Technical Service Bulletin

01 Engine Crankcase breather Whistling Noise and DTC P227900 warning light ON

01 23 79 2069351/4 September 20, 2023. Supersedes Technical Service Bulletin Group 01 number 23-59 dated June 28, 2023, for reasons listed below.

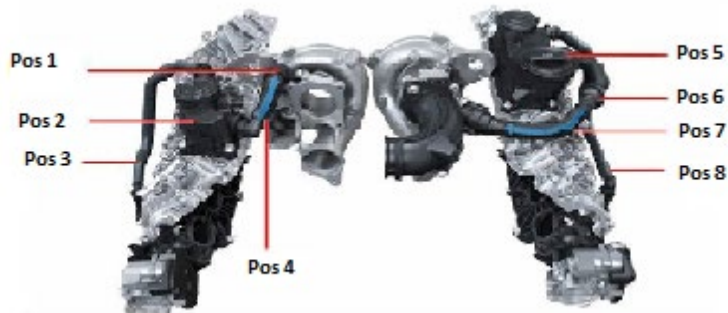
Improved crankcase full load breather line for bank 1 have been implemented in production between the end of Q2 2021 and the start of Q4 2021, depending on engine version. See table below:

In this case, replace the full load breather line for cylinder bank 1.

1. Do not replace the oil separator for bank 1 or bank 2 or the part load breather lines.
2. Please refer to image of the crankcase breather from the Self Study Program 920493 as a guide.

Item 4: Full load breather line for bank 1 (Replacement required)
